2.0 SAFETY LIMITS AND LIMITING SAFETY SYSTEM SETTINGS

8604100201 860331
PDR ADOCK 05000416
P PDR

INSERT FOR
TABLE 2.2.1-1
ITEM 2.b

Insert 3/4.4-1 page 1 of 2

FIGURE 3.2.1-1 MAXIMUM AVERAGE PLANAR LINEAR HEAT GENERATION RATE (MAPLHGR) VERSUS AVERAGE PLANAR EXPOSURE
INITIAL CORE FUEL TYPES 8CR210, 8CR160 AND 8CR071

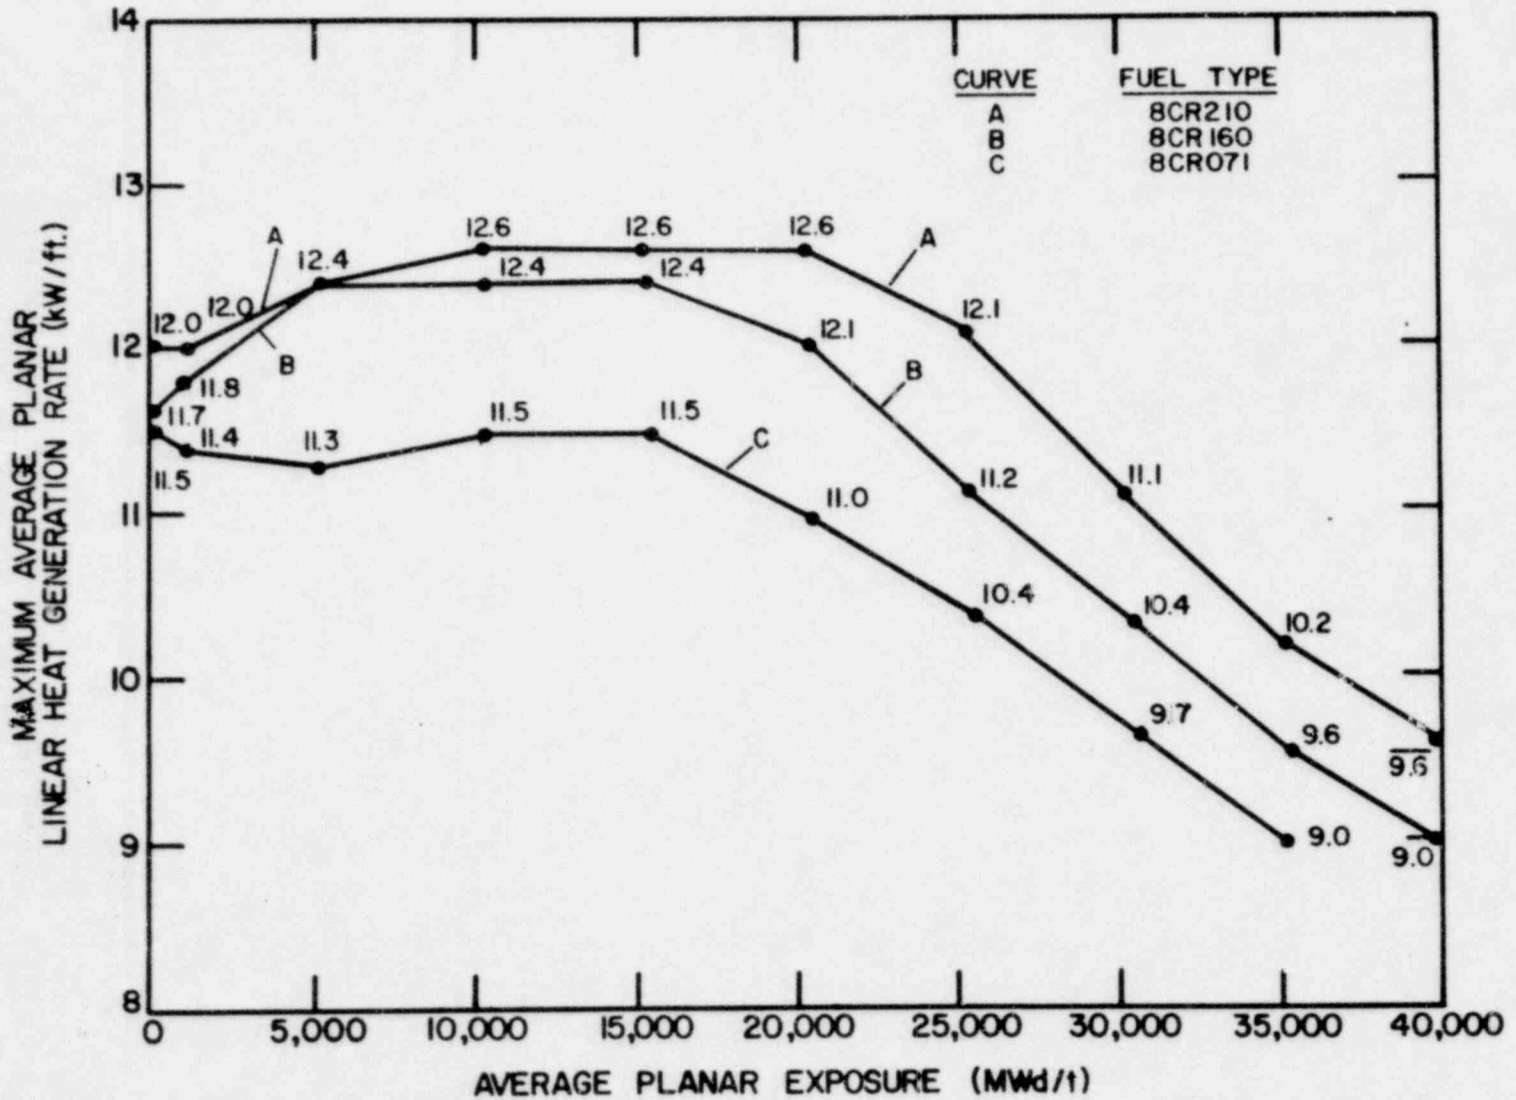
3.2.1 All AVERAGE PLANAR LINEAR HEAT GENERATION RATES (APLHGRs) for each type of fuel as a function of AVERAGE PLANAR EXPOSURE shall not exceed the limits shown in Figure 3.2.1-1 ~~during two loop operation~~ or in Figure 3.2.1-2 ~~during single loop operation~~.

FOR TWO LOOP OPERATION

for two loop operation and Figure 3.2.1-2 for single loop operation. The single loop operation limits are lower to account for earlier boiling transition assumed in the single loop operation LOCA analysis.

FIGURE 3.4.1.1-1 POWER - FLOW OPERATING MAP

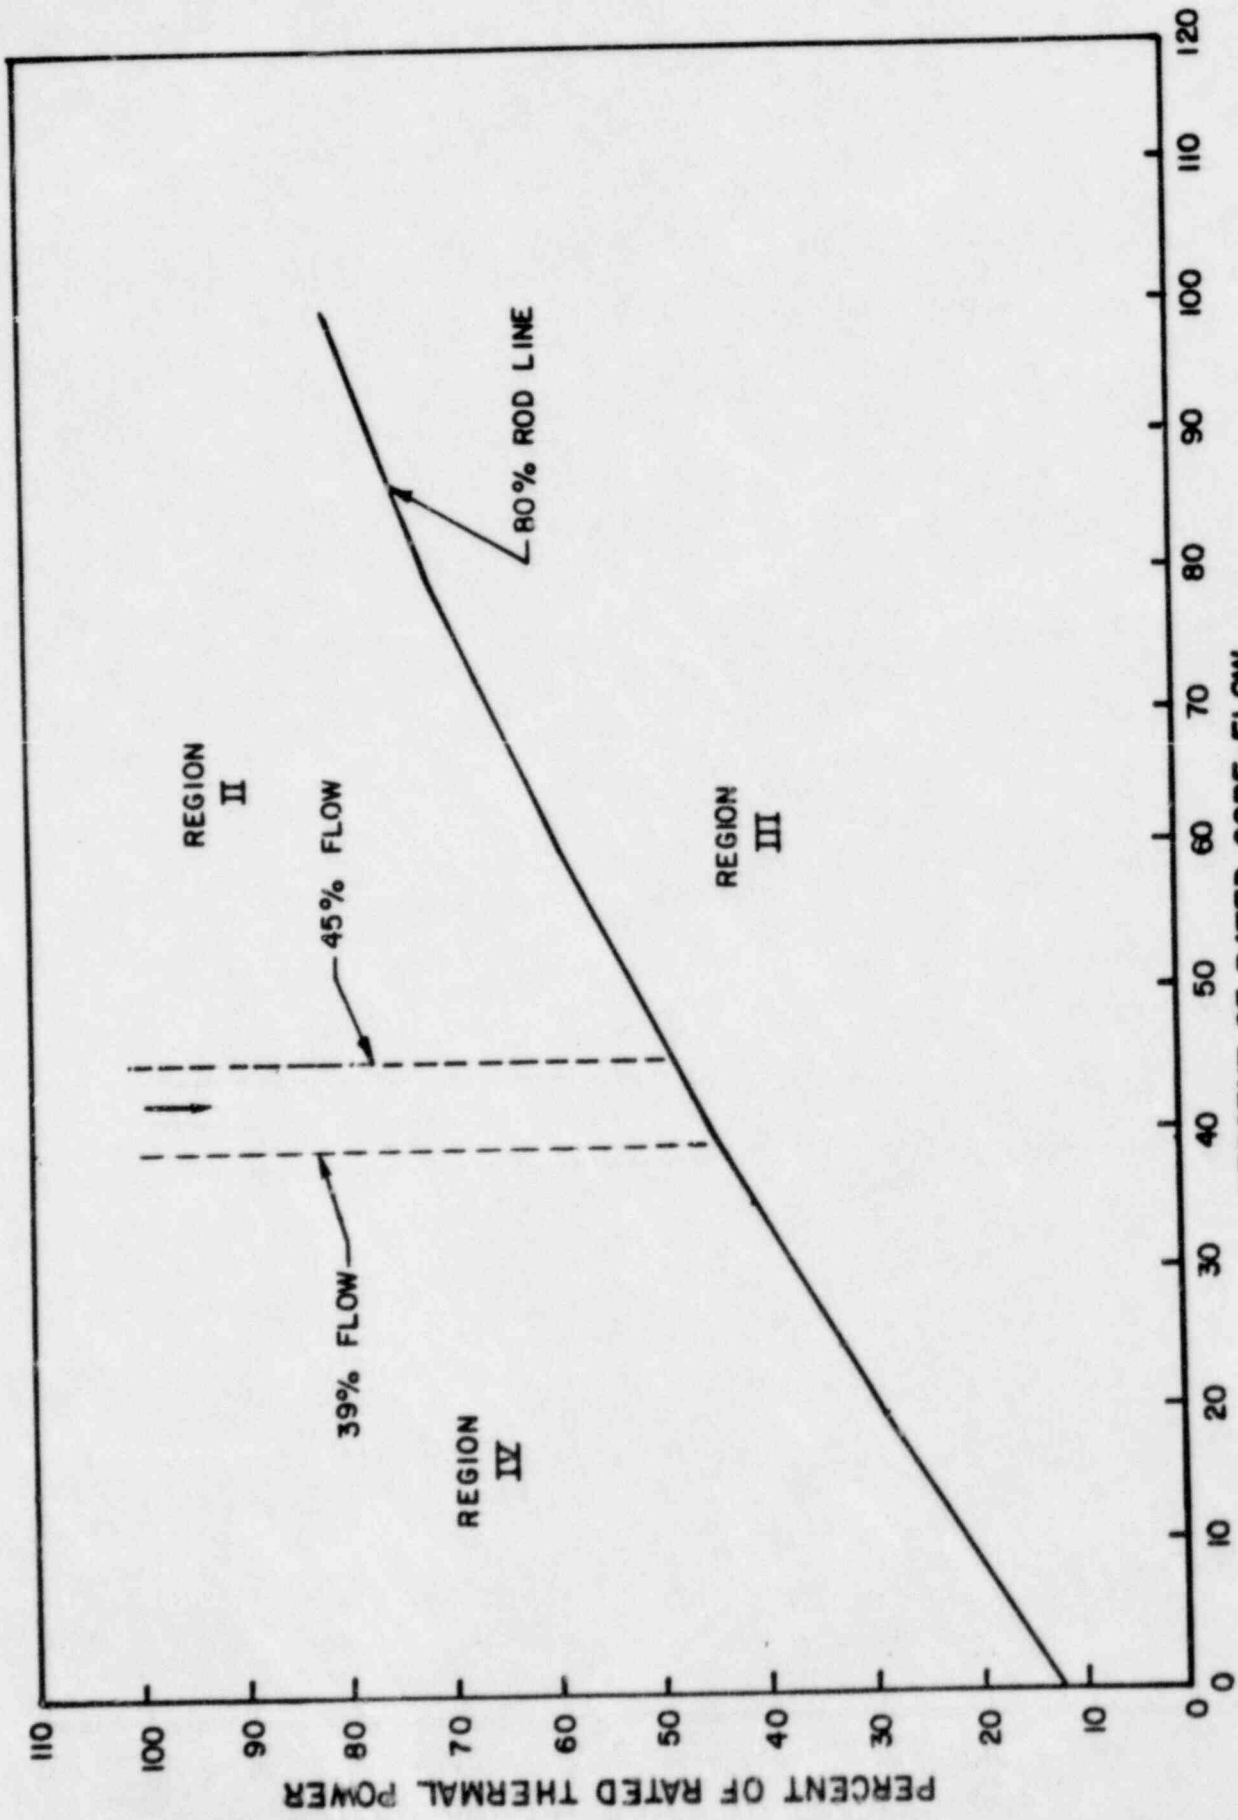
- 3.4.1.1 The reactor coolant recirculation system shall be in operation and not in Region IV as specified in Figure 3.4.1.1-1 with either:
- a. Two recirculation loops operating with limits and setpoints per Specifications 2.1.2, 2.2.1, 3.2.1, 3.2.2 and 3.3.6, or
 - b. A single recirculation loop operating with:
 - 1) a volumetric loop flow rate less than 44,600 gpm, and
 - 2) the loop recirculation flow control in the manual mode, and
 - 3) limits and setpoints per Specifications 2.1.2, 2.2.1, 3.2.1, 3.2.2, and 3.3.6.

- e. With operation in Region IV as specified in Figure 3.4.1.1-1, initiate corrective action within 15 minutes to either reduce power to within Region III of Figure 3.4.1.1-1 or increase flow to within Region I or Region II of Figure 3.4.1.1-1 within 4 hours.

- 4.4.1.1.1 The reactor coolant recirculation system shall be verified to be in operation and not in Region IV of Figure 3.4.1.1-1 at least once per 24 hours.
